**CARLTON AND UNITED BREWERIES  
CONCEPT PLAN - A SUBMISSION BY  
THE CITY OF SYDNEY**

# CARLTON AND UNITED BREWERY SITE CONCEPT PLAN

A Submission by the Council of the City of Sydney

November 2006

Figure 2. Significant items to be demolished under Concept Plan (Source, NBR&P, Carlton and United Brewery site CMP, 2005)

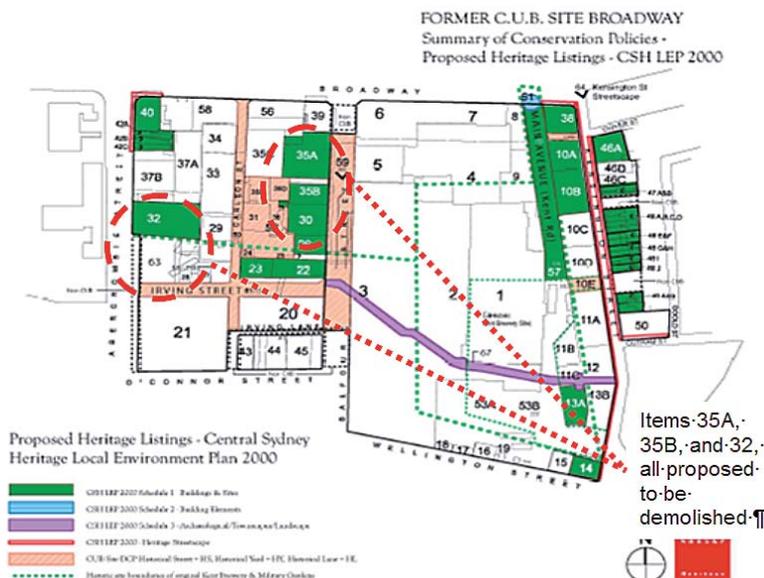
**Heritage:** the destruction of much of the **built** heritage and unique character of the site to make way for Tooth Avenue and taller buildings is a very poor urban design outcome. In particular, the concept plan proposes the demolition of three significant buildings:

- Buildings 35A (the 'Sunburst building') and 35B, both an integral part of the Irving Street Brewery complex. Irving Street had been proposed as a 'Special Area' in the City of Sydney's draft Planning Package, in recognition of its rareness as a surviving early twentieth century inner-city industrial precinct, and its potential to generate a specific character and 'sense-of-place' for the development; and
- Building 32, significant for its pioneering use of pre-cast concrete construction techniques.

The Conservation Management Plan prepared by the proponent and endorsed by the Council, the CSPC, and the NSW Heritage Office, recommended that all three of these buildings be conserved and adapted for reuse.

Figure 3: Proposed CUB concept plan - land use

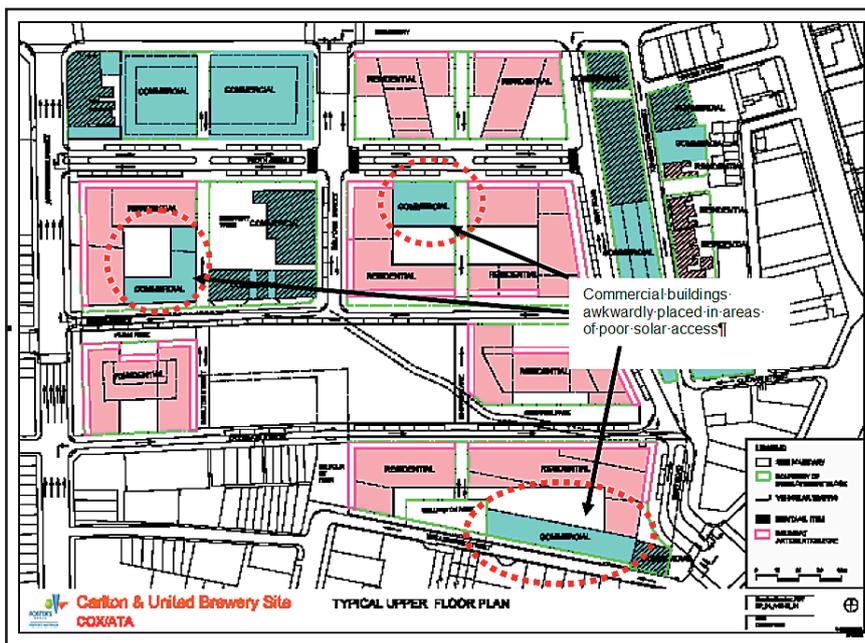
However, it should be noted that the proportion of residential uses has been reduced to approximately 59% (down from 70% as previously proposed). The placement of commercial buildings is awkward and does not fit into any logical land use pattern. The reason that the commercial proportion in the concept plan has been increased is to ensure that the concept plan will meet the SEPP 65 solar amenity requirements of 2 hours of sunlight to at least 70% of apartments in mid winter. If the residential proportion was increased then it would not be possible to meet these requirements. Therefore the combination of additional density with land use means that the Major Projects SEPP amendment permits a development that cannot meet SEPP 65 solar amenity requirements.

Figure 4: Street Layout proposed by the Draft DCP

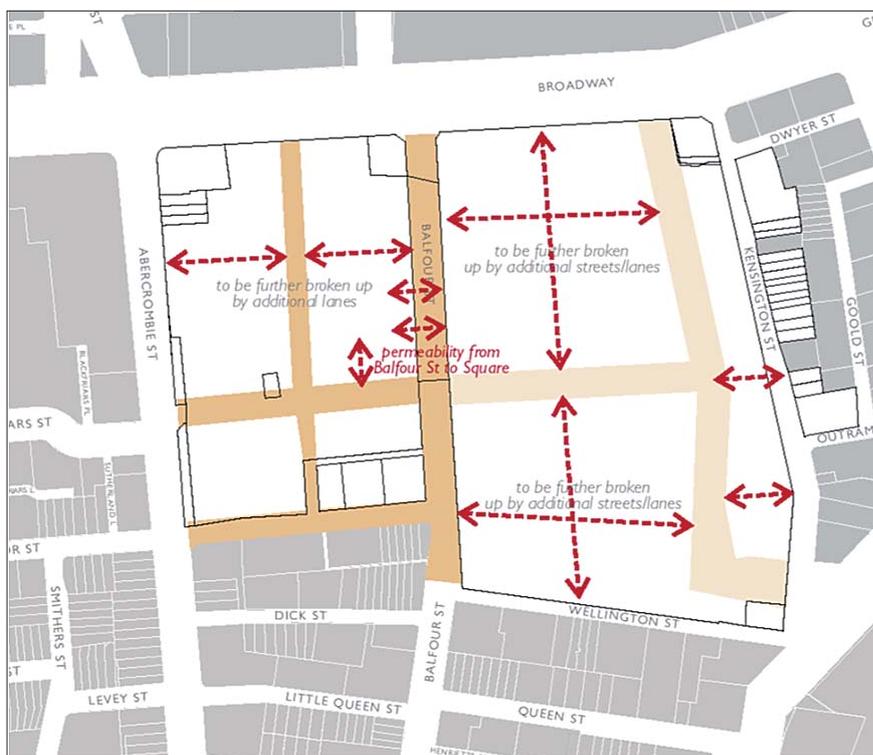
Of particular concern to the City is the street layout put forward by the concept plan. While being partly based on the existing heritage grid, the concept plan introduces a new street "Tooth Avenue". Figure 4 contains the City's preferred layout. The inclusion of the street raises a number of significant issues including:

- the street is an east west street which is surrounded by tall buildings. This means that it will not receive adequate solar access and is likely to have a dark and enclosed 'feel', particularly in Winter;
- the street width proposed for Tooth Avenue (being 20m) is excessive and out of keeping with the nature of the site and streets in Chippendale;
- Tooth Avenue would require the removal of significant buildings that are identified as having heritage significance; and
- Tooth Avenue does not link with any other areas and therefore will have difficulty in becoming a high street as envisioned by the proponents. A more natural street for this function is Balfour Street which links the site to Broadway and Chippendale.
